# Recall Bulletin

## PRODUCT SAFETY RECALL

**SUBJECT:** Fuse Block Retention

**MODELS:** 2015 Chevrolet Silverado HD  
2015 GMC Sierra HD  
Equipped With 220 Amp Generator (KW5)

3709065

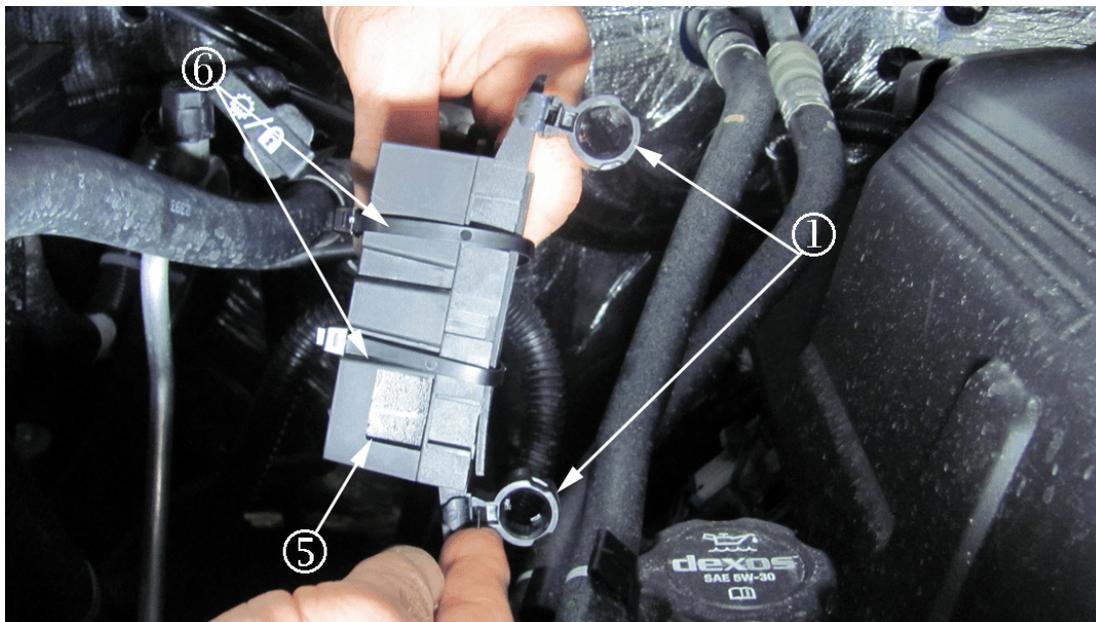
- A fuse block housing assembly that has NOT been reworked will have two brown clips (1) that secure the fuse block housing assembly to the shock tower studs. The fuse block housing cover will also NOT have a black polyolefin side window shield (5) or a black polyolefin bottom shield that is secured to the fuse block housing assembly with two black tie straps. **If a fuse block housing assembly rework has NOT been performed, perform the rework procedure in this bulletin. Proceed to step 3.**

- A first design reworked fuse block housing assembly will have two black clips (1) that secure the fuse block housing assembly to the shock tower studs. The fuse block housing cover will also have a black polyolefin side window shield (5) and the bottom of the fuse block housing will have black polyolefin bottom shield that is secured to the housing assembly with two black tie straps (6). **If the first design rework has been completed, no further action is required.**
3. Disconnect the negative battery cable. Refer to Battery Negative Cable Disconnection and Connection in SI.

3824956

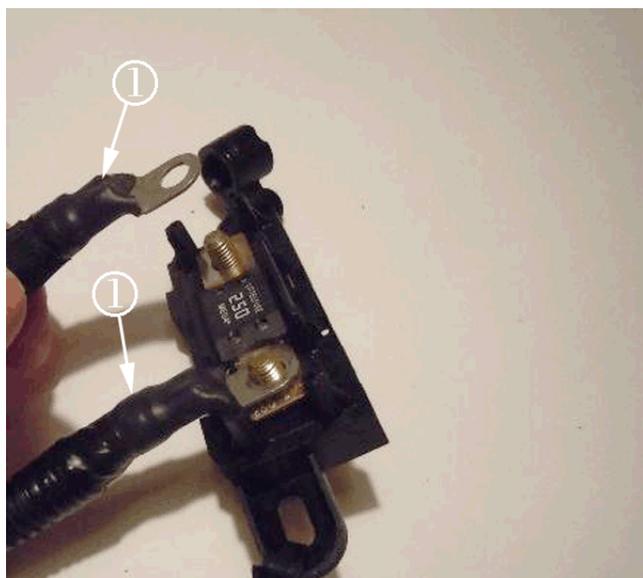
**Note:** In the current design fuse base, these geometric shaped inserts (2) face the cables as shown in the photograph. When you install the NEW fuse base, these inserts (2) will face AWAY from the cables, allowing the new gaskets to seal best.

- 8. Re-install ring terminals (1) to studs. Note that the new fuse base (5) will be flipped 180 degrees from how it was before, with the FLATS facing the cables. The generator cable (6) is on the left in the picture.
- 9. Using a torque wrench, torque both nuts over the ring terminals (1) to 15 Nm (11 lb-ft). Make SURE the geometric inserts (2) are AWAY from cables as shown.

3824944

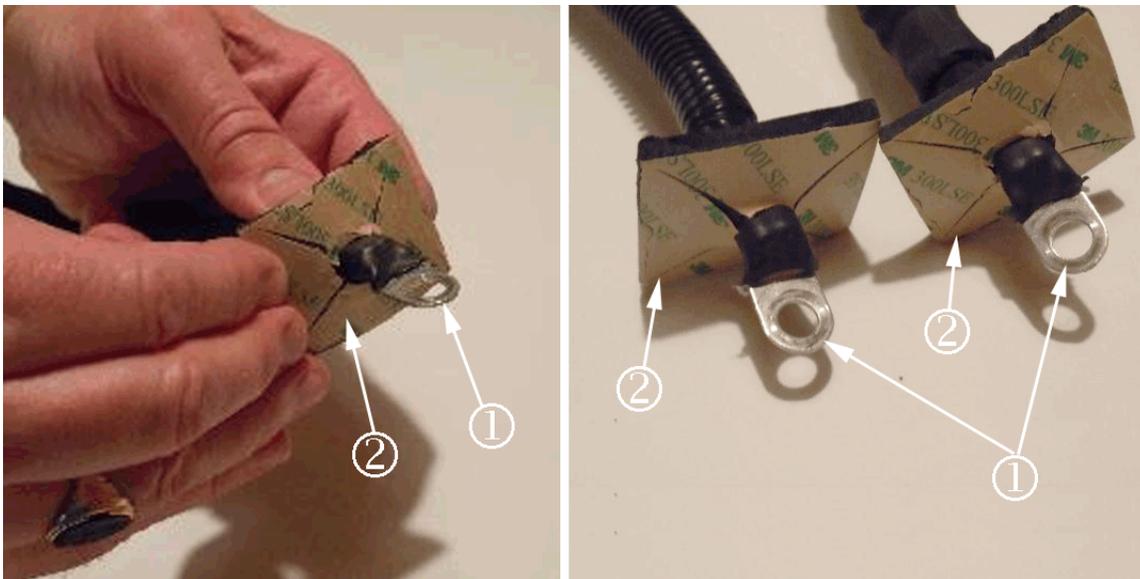
**Note:** The first design rework kit is no longer available. Use a second design rework kit to update the fuse block assembly. The second design rework kit consists of two foam gaskets with paper backing (2), a new fuse cover with lower mouse hole flashed over (1), and new base with stud bases covered in non-conductive epoxy (includes 250A fuse and nuts) (3). The black mounting clips (4) are attached to the fuse body.

3824980

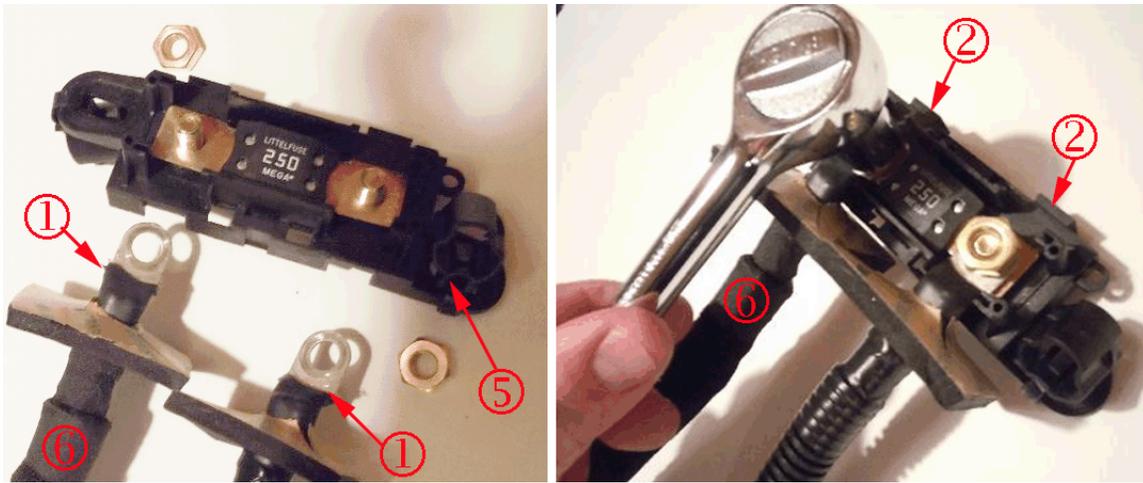
**Note:** The rectangle foam gaskets are 40mm x 50mm (1.57 in x 2.0 in). The long side of the foam gasket runs parallel with the ring terminal flats as shown in photograph.

7. With the paper backing facing away from the cable, insert the foam gasket (2) through ring terminal (1) as shown in the photograph. Perform this step on both ring terminals.
